**寄件者:** Chong Hermose <[REDACTED]>  
**寄件日期:** 2026年05月12日星期二 13:44  
**收件者:** tpbpd/PLAND  
**副本:** David Chi Chiu CHENG/PLAND; Ivan Sze Yuet FUNG/PLAND  
**主旨:** A/YL-KTN/1198 : 回應部門意見  
**附件:** 回應部門意見\_20260512.pdf; 附件1 : Revised Drainage Proposal.pdf  
**類別:** Internet Email

## Planning Application No. A/YL-KTN/1198

Table A: Responses to Departmental Comments

TEMPORARY DRAINAGE PROPOSAL FOR THE PROPOSED TEMPORARY PLACE OF RECREATION, SPORT OR CULTURE (PADEL TENNIS) WITH ANCILLARY EATING PLACE AND SHOP AND SERVICES FOR A PERIOD OF 3 YEARS AT LOT 1560 (PART) IN D.D.107 AND ADJOINING GOVERNMENT LAND, KAM TIN, YUEN LONG, NEW TERRITORIES

PROPOSED DRAINAGE WORKS

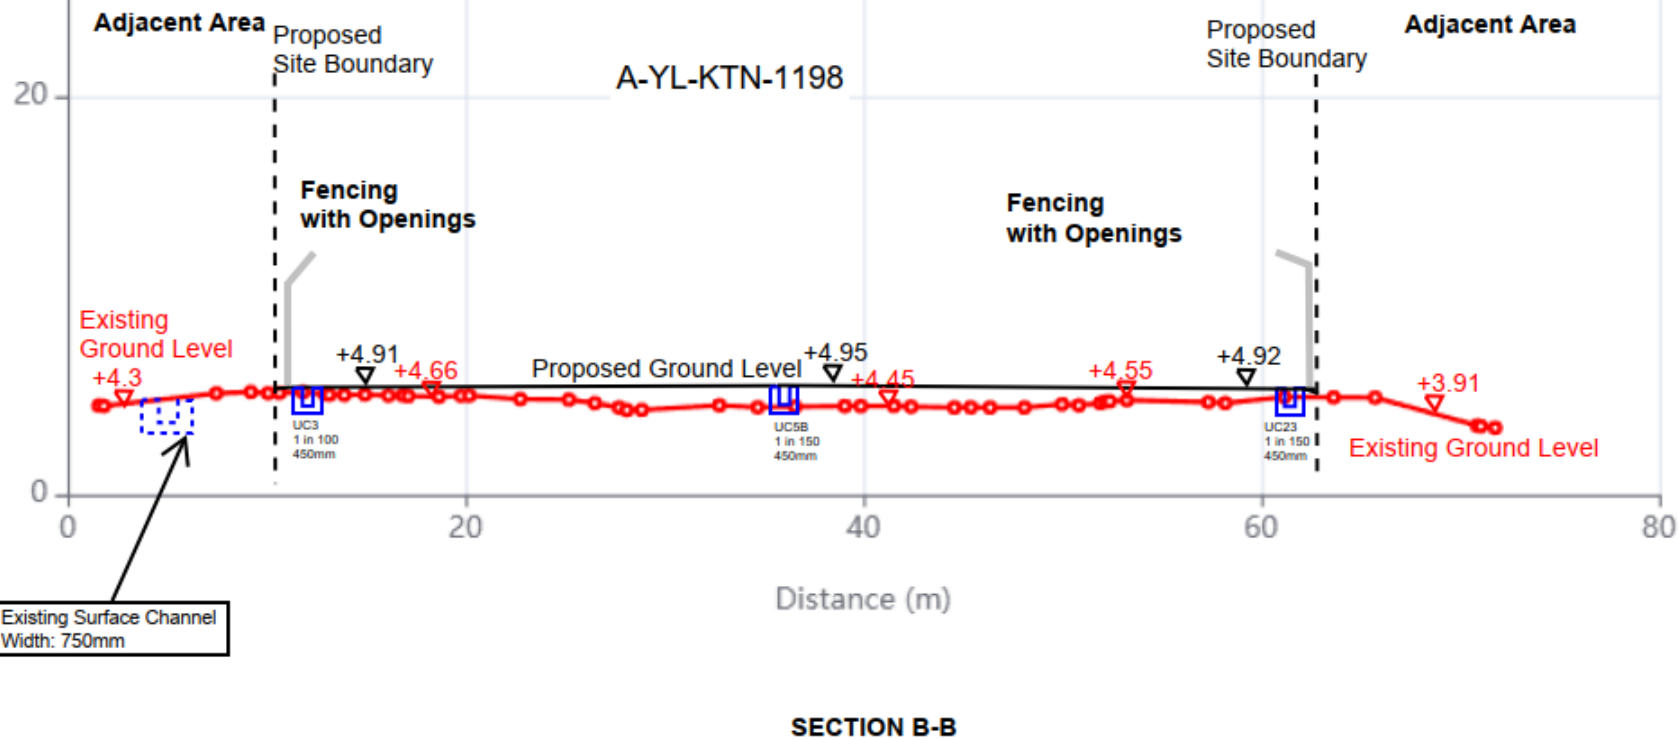
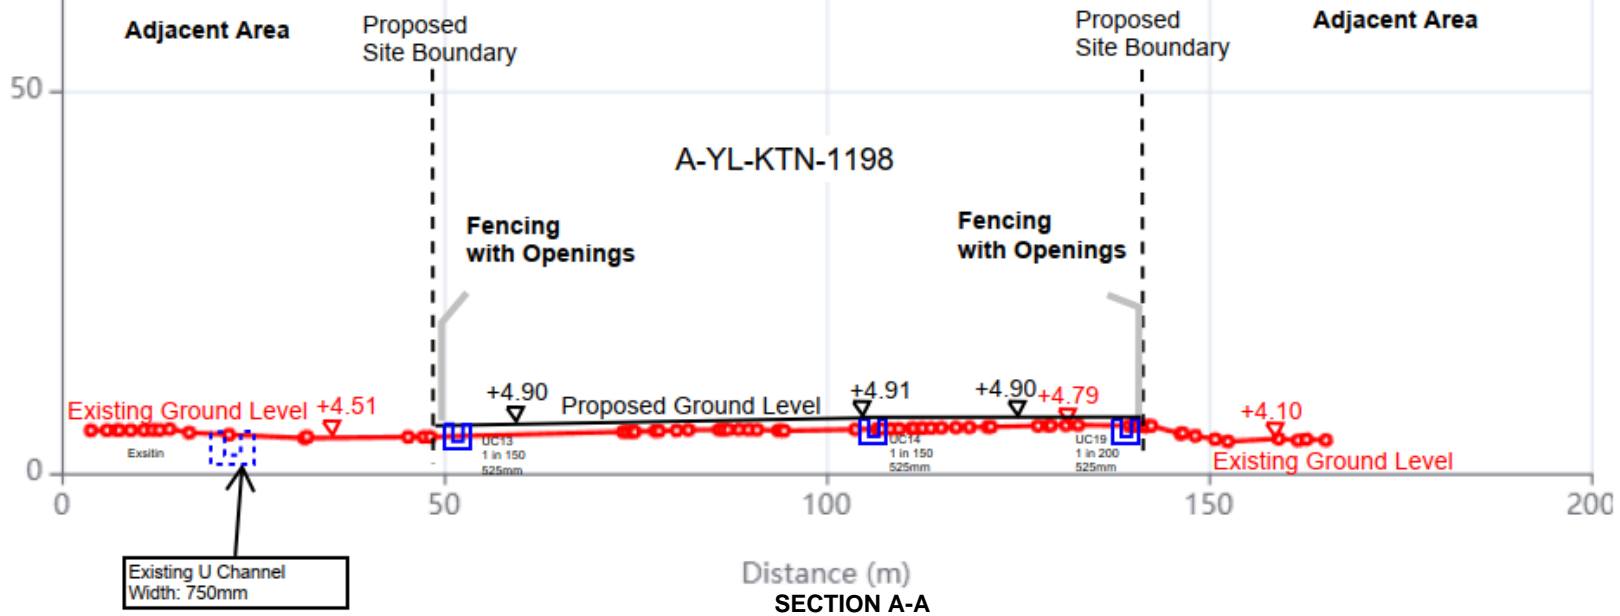
<b>Departmental Comments</b>	<b>Responses</b>
	<b>Drainage Services Department</b>	
1	<p>1. The applicant should indicate the proposed and existing ground levels of the application site and ground levels of adjacent areas on the drainage plan and cross sections. Also, the applicant should indicate flow direction of runoff at the adjacent areas of the application site. Since the overland flow from the adjacent lands shall be probably intercepted, external catchment shall be considered in the calculation. Peripheral surface channels shall be provided along the site boundary to collect the surface runoff accrued on the application site and to intercept the overland flow from the adjacent lands. The applicant should demonstrate catchment area considered in the proposal is adequate.</p> <p>2. The applicant should review the submitted cross sections as they are not aligned with the submitted drainage plan.</p> <p>3. According to the submitted cross sections, it is noted that there is proposed land filling works for the development. Proper surface channels should be provided at the lower level and wall toe to collect the overland flow to/ from adjacent areas. Also, the applicant did not mention the proposed land filling works in the application form. The applicant should clarify depth of the proposed land filling works in the planning application form.</p> <p>4. The applicant should demonstrate</p>	請看附件 1 : Revised Drainage Proposal

The runoff from the application site is proposed to be collected by U-channels along the site boundary and discharged to the four terminate catchpits with sand trap and eventually lead to the existing open channels in vicinity of the site. Cover levels and invert levels of both the proposed and existing drainage facilities were shown on the drainage plan. The invert levels of the upstream drainage facilities were higher than those at the downstream to ensure proper flow direction. In addition, the gradients and sizes of the proposed and existing drainage facilities were also indicated on the drainage plan. The detail of the proposed drainage works in drainage plan are illustrated in **Appendix D1**.

Appendix F  
Design Checking for Existing Drainage System

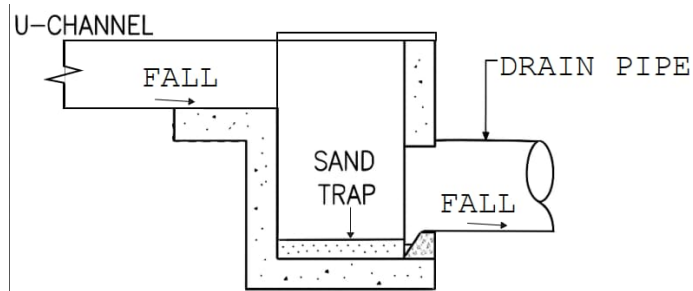
<p>with hydraulic calculation that the proposed drainage facilities are adequate to collect, convey and discharge the surface runoff accrued on the application site and the overland flow intercepted from the adjacent lands. Also, the applicant should demonstrate the existing facilities to be discharged to have sufficient capacity to cater for any additional flow generated due to the subject application.</p> <p>5. Photo 2: Internal condition of existing drainage facilities could not be seen.</p> <p>6. The applicant should provide site photos to show connection of existing 750 mm (W) surface channel and public drainage system mentioned in the proposal.</p> <p>7. The applicant should review formula used for calculating time of concentration and roughness coefficient adopted in the submitted hydraulic calculation. Stormwater Drainage Manual and the newly promulgated Corrigenda No. 1/2022 and 1/2024 shall be considered in the hydraulic calculation.</p> <p>8. Deposition of sediment in drainage system should be considered in the hydraulic calculation as per the requirement in Stormwater Drainage Manual (Section 9.3).</p> <p>9. Appendix F: The applicant should provide an assessment of the overall utilization of the existing drainage system.</p> <p>10. Appendix F: The submitted hydraulic calculation did not cover all existing</p>

<p>facilities to be discharged. The applicant should supplement hydraulic calculation.</p> <p>11. Appendix F: The applicant should clarify existing drainage facilities to be discharged at location DP2 mentioned in the proposal.</p> <p>12. The applicant should provide details for the connection of the proposed and existing drainage facilities mentioned in the proposal.</p> <p>13. The gradients and the sizes of the proposed drainage facilities should be shown on the drainage plan.</p> <p>14. The applicant should clarify invert level of the existing drainage facilities mentioned in the proposal. Invert levels of drainage facilities at the upstream shall be higher than that at the downstream.</p>	
--	---	--

Moreover, separate hydraulic calculation has been checked for the existing facilities to be discharged to have sufficient capacity to cater for application site, it is appended in **Appendix F**.

To confirm that the receiving drainage facilities have sufficient capacity to accommodate the discharge from the application site, additional hydraulic calculations were carried out on existing 750 mm U-channel and 6500mm open channel in the vicinity of the application site. The results are summarized in **Table 3** and appended in **Appendix F**. This demonstrates that the proposed development will not adversely affect the existing drainage system.
